SUBJECT: Addendum #1 – Removal of Contractors option to submit a Pre-Cast Alternative to NCDOT for WBS#17BP.10.R.19.

PROJECT NO. 17BP.10.R.19

DOUBLE 12 FT. X 5 FT.
 CONCRETE BOX CULVERT
 75° SKEW

SHEET 1 OF 3 REPLACES BR. NO. 366

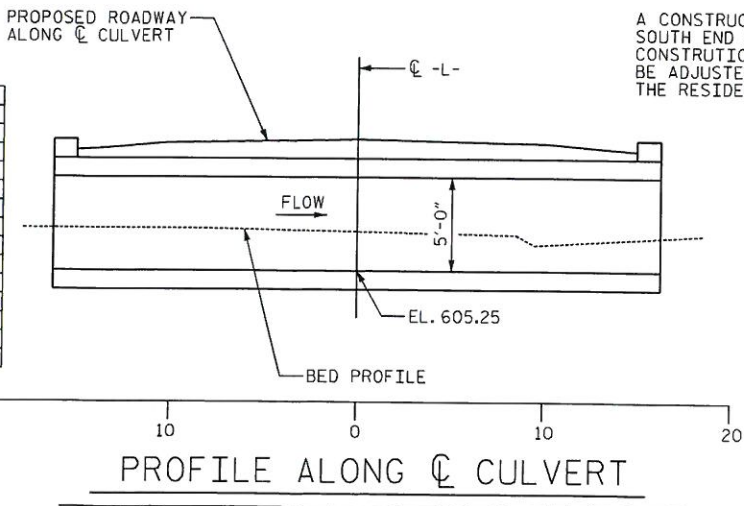
The existing Structure Plans have a note on Page # C-1 that states the Contractor has the option to submit a Design to the Department for a PRECAST REINFORCED CONCRETE BOX CULVERT as an alternative for the CAST in PLACE CULVERT, this **WILL NOT** be an option.
